1984 Corvette: Recall: Positive Battery Cable Routing

Number: 84C04, Number XII

Date: August, 1983

Subject: PRODUCT SAFETY CAMPAIGN 84C04
POSITIVE BATTERY CABLE ROUTING
1984 CORVETTE

Figure 1

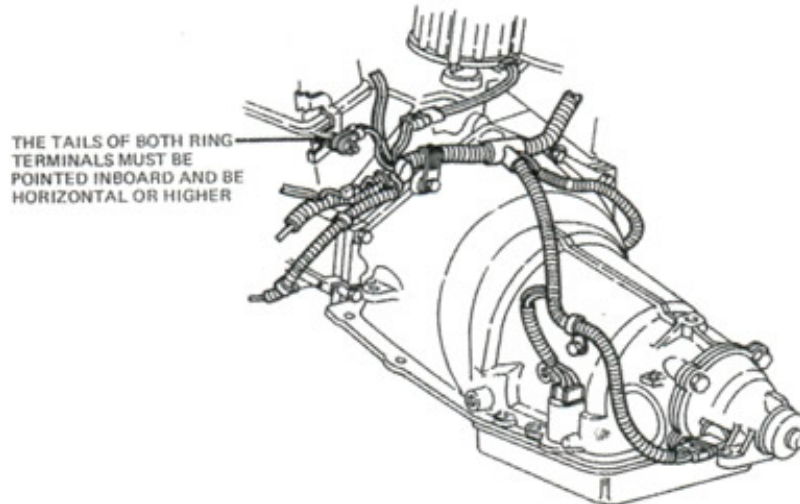
4. Loosen the ground stud nut on the left hand rear cylinder head and reposition both (2) ground wire ring terminals. Terminals are to point inboard and be horizontal or higher. (Figure 1)
5. Thread the kit supplied conduit over the positive battery cable. The inboard end of the conduit should extend inboard beyond the (ground stud) repositioned ground ring terminals.

Figure 2

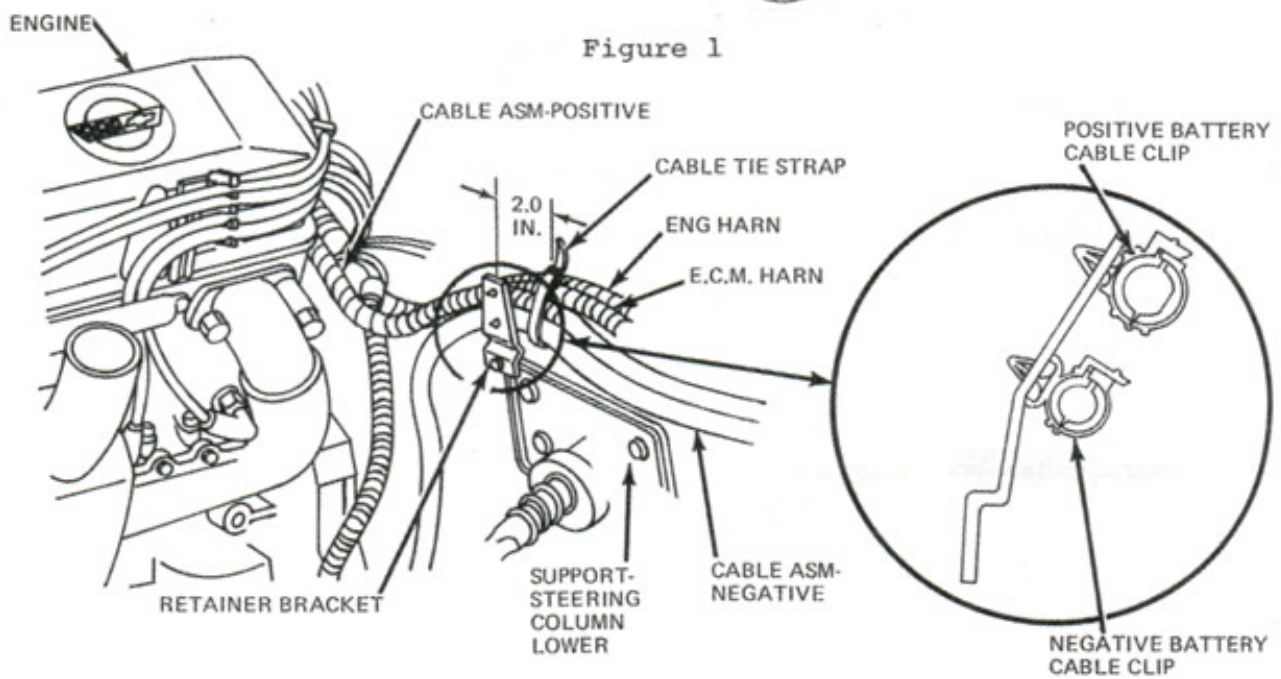
6. Install the supplied conduit clips on supplied bracket. The larger inside diameter clip in the top hole and the smaller in the lower hole. Both battery cables must be routed on the rear side of the new harness bracket. (Figure 2)
7. Align bracket to stud or attaching bolt hole and lock lower clip to negative battery cable. Lock upper clip to conduit on the positive battery cable.

THE UPPER (POSITIVE) CABLE CLIP IS TO BE LOCATED AND LOCKED 51MM (2.0 IN.) INBOARD FROM THE OUTBOARD END OF THE CONDUIT. (FIGURE 2)
